Economic Commission for Europe**Inland Transport Committee****World Forum for Harmonization of Vehicle Regulations****Working Party on Lighting and Light-Signalling****Seventy-seventh session**

Regulations Nos. 37 (Filament lamps), 99 (Gas discharge light sources), 128 (Light emitting diodes light sources) and the Consolidated Resolution on the common specification of light source categories**Proposal for amendments to the original version of the Consolidated Resolution on the common specification of light source categories****Submitted by the expert from the International Automotive Lighting and Light Signalling Expert Group (GTB)***

Figure 1
main drawing

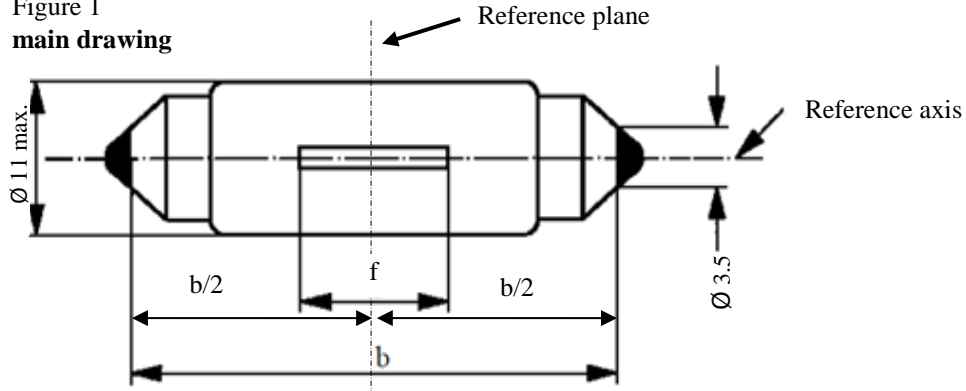
Before sheet LR1/1, insert new sheets C5W/LED/1 to 4, to read (see following pages; one page per sheet):

Dimensions in mm		LED light sources of normal production			Standard LED light source
		min.	nom.	max.	
b ^{1/}		34.0	35.0	36.0	35±0.5
e ^{2/}			0.0		0.0
f ^{2/}			9.0		9.0
Cap SV8.5 in accordance with IEC Publication 60061 (sheet 7004-81-4)					
Electrical ^{5/} and photometric characteristics					
Rated values	Volts	12			12
	Watts	2			2
Test voltage	Volts	13.5			13.5
Objective values	Watts	2 max.			2 max.
	Electrical current (in mA at 9-16V DC)	75 min. 170 max.			
	Luminous flux ^{3/} (in lm at 13.5 V DC)	45 ± 20 % ^{4/}			45 ± 10 % ^{4/}
	Luminous flux ^{3/} (in lm at 9 V DC)	9 min.			9 min.

Figure 2

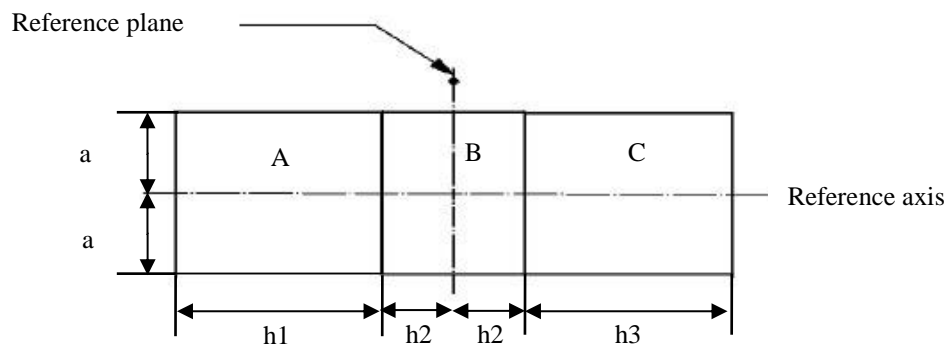
The proportion of the total luminous flux emitted into these viewing directions from the area(s) as defined in figure 2:

- A, B and C together shall be 70 per cent or more
- B shall be 20 per cent or more
- A and C shall each be 15 per cent or more

Dimension (mm)	<i>a</i>	<i>h1, h3</i>	<i>h2</i>
All views (as specified above)	2.5	6	2

Figure 3

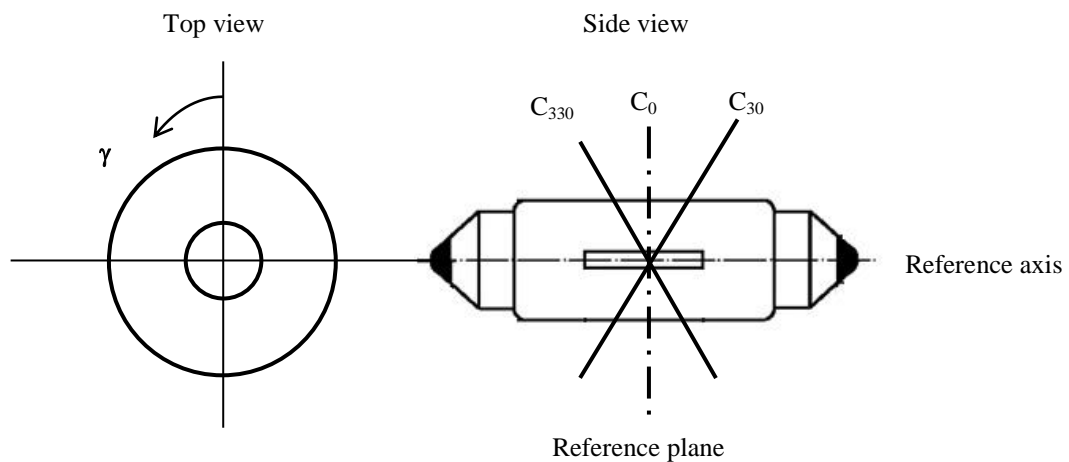
The measurements shall be performed in C-planes, where C_0 shall be the reference plane of the light source. The C-planes to be measured shall be C_0 , C_{30} and C_{330} . The test points for each plane and multiple polar angles γ are specified in Table 3.

The measured luminous intensity values, normalised to the measured luminous flux of the individual light source under test, shall be converted to normalised luminous intensity values of a 1000 lm light source. These data shall comply with the tolerance band as defined in Table 3.

Figure 1

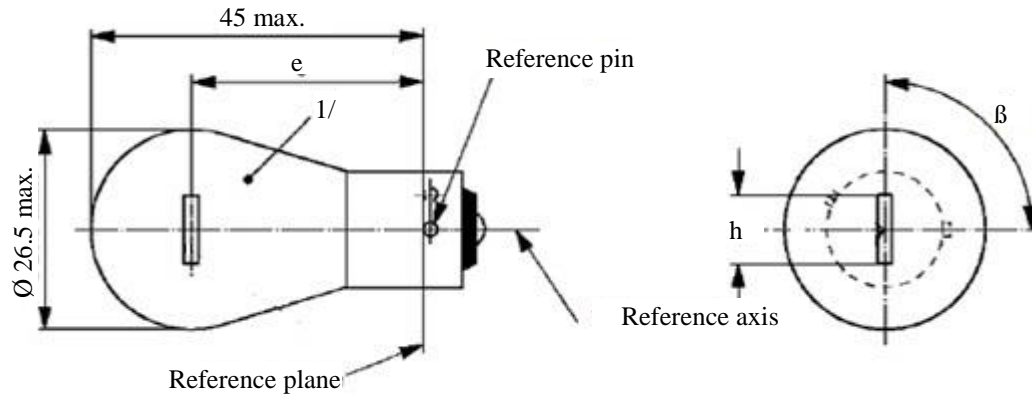
After sheet L5/6, insert new sheets PY21W/LED/1 to 4 and R5W/LED/1 to 4, to read (see following pages; one page per sheet):

Dimensions in mm		LED light sources of normal production			Standard LED light source
		min.	nom.	max.	nom.
e			31.8 ^{2/}		31.8 ^{2/}
h			9.0 ^{2/}		9.0 ^{2/}
β		75°	90°	105°	90°±10°
Cap BAU15s in accordance with IEC Publication 60061 (sheet 7004-19-2)					
<i>Electrical^{5/} and photometric characteristics</i>					
Rated values	Volts	12	24		12
	Watts		7 ^{3/}		7 ^{3/}
Test voltage	Volts	13.5	28.0		13.5
Objective values	Watts	9 max. ^{3/}	10 max. ^{3/}		9 max. ^{3/}
	Electrical current (in mA at 9-16V DC)	150 min. 750 max.			
	Luminous flux ^{3/, 4/} (in lm at 13.5 V DC)	280 ± 20 %			280 ± 10 %
	Luminous flux ^{3/} (in lm at 9 V DC)	56 min.			56 min.

Figure 2

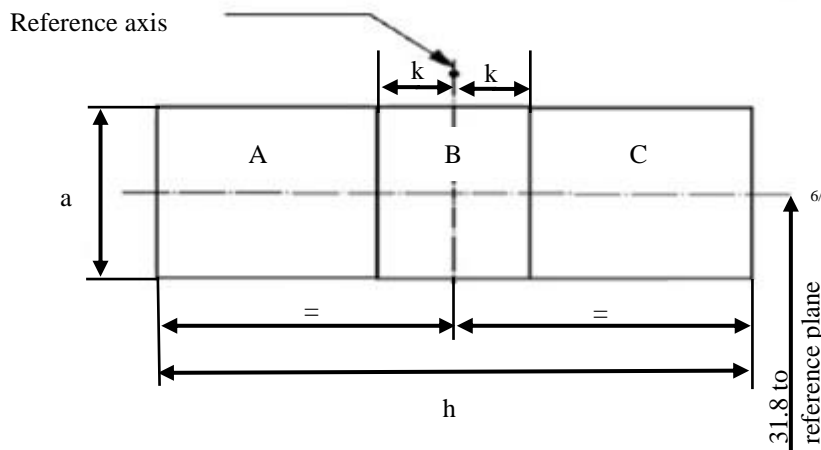
The proportion of the total luminous flux emitted into these viewing directions from the area(s) as defined in figure 2:

- A, B and C together shall be 80 per cent or more
- B shall be 25 per cent or more
- A and C shall each be 15 per cent or more.

Dimensions in mm	<i>a</i>	<i>h</i>	<i>k</i>
Top view ($\gamma = 0^\circ$)	5.0	9.0	1.0
Inclined view ($\gamma = \pm 45^\circ$)	7.0		
Front / Rear view ($\gamma = \pm 90^\circ$)	5.0

Figure 3

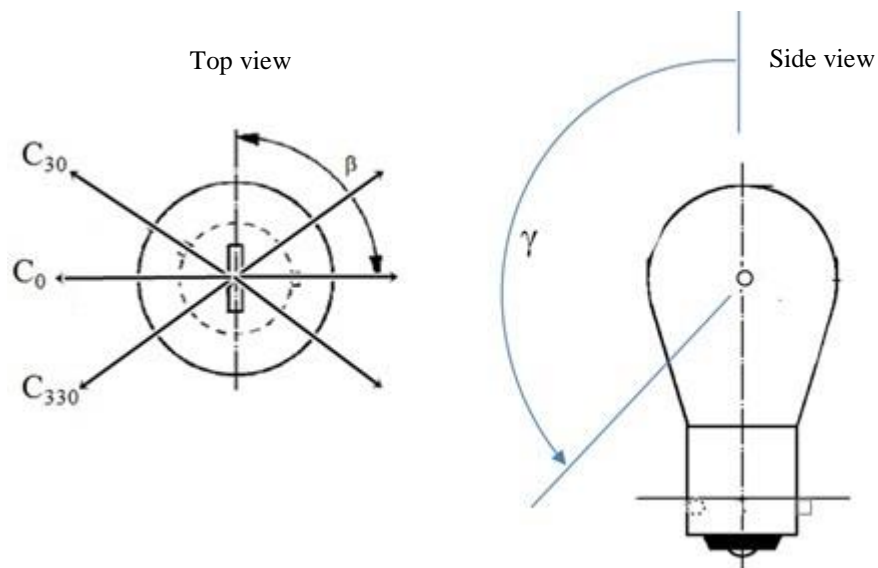
The measurements shall be performed in C-planes, which contain the reference axis of the light source. The C-planes shall be C_0 , C_{30} and C_{330} . The test points for each plane and multiple polar angles γ are specified in Table 3.

The measured luminous intensity values, normalised to the measured luminous flux of the individual light source under test, shall be converted to normalised luminous intensity values of a 1000 lm light source. These data shall comply with the tolerance band as defined in Table 3.

Figure 1
Main drawing

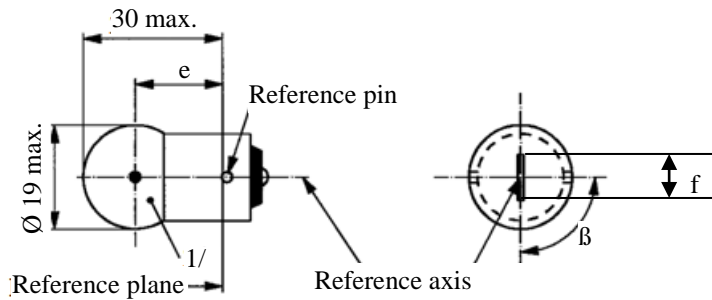
Dimensions in mm		LED light sources of normal production			Standard LED light source
		min.	nom.	max.	nom.
e ^{2/}			19.0		19.0
f ^{2/}			4.0		4.0
β ^{2/}			90°		90°
Cap: R5W: BA15s in accordance with IEC Publication 60061 (sheet 7004-11A-9)					
Electrical ^{4/} and photometric characteristics					
Rated values	Volts		12	24	12
	Watts		2		2
Test voltage	Volts		13.5	28.0	13.5
Objective values	Watts		2 max.	2 max.	2 max.
	Electrical current (in mA at 9-16V DC)		75 min. 170 max.		
	Luminous flux ^{1/,3/} (in lm at 13.5 V DC)		50 ± 20 %		50 ± 10 %
	Luminous flux ^{1/} (in lm at 9 V DC)		10 min.		10 min.

Figure 2

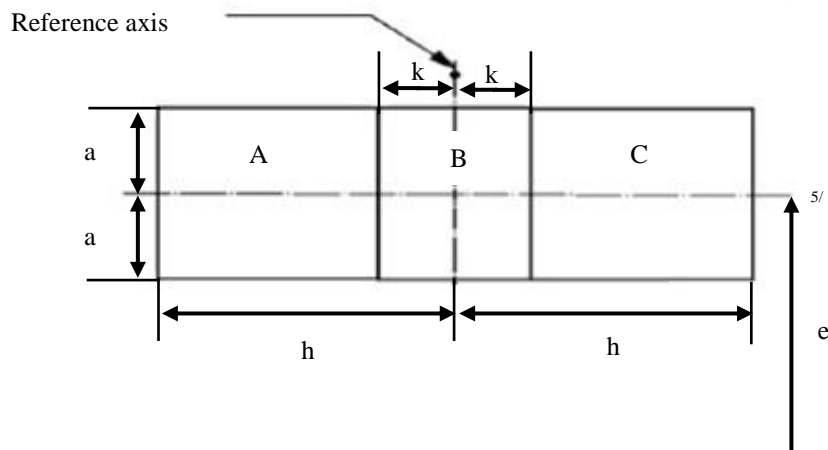
The proportion of the total luminous flux emitted into these viewing directions from the area(s) as defined in figure 2:

- A, B and C together shall be 70 per cent or more
- B shall be 20 per cent or more
- A and C shall each be more than 15 per cent

<i>Dimensions in mm</i>	<i>a</i>	<i>h</i>	<i>k</i>
Top view ($\gamma = 0^\circ$)	3	4	0.5
Inclined views ($\gamma = \pm 45^\circ$)	4.5	4	0.5
Front/ Rear view ($\gamma = \pm 90^\circ$)	3	4	0.5

Figure 3

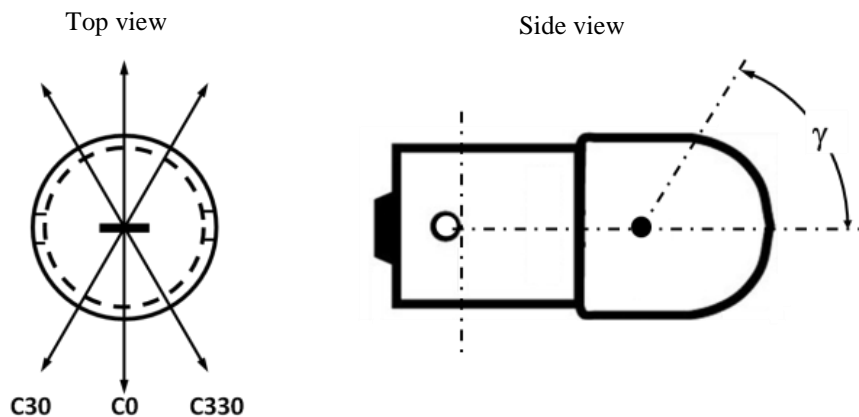
The measurements shall be performed in C-planes, which contain the reference axis of the light source. The C-planes to be measured shall be C_0 , C_{30} and C_{330} . The test points for each plane and multiple polar angles γ are specified in Table 3.

The measured luminous intensity values, normalised to the measured luminous flux of the individual light source under test, shall be converted to normalised luminous intensity values of a 1000 lm light source. These data shall comply with the tolerance band as defined in Table 3.
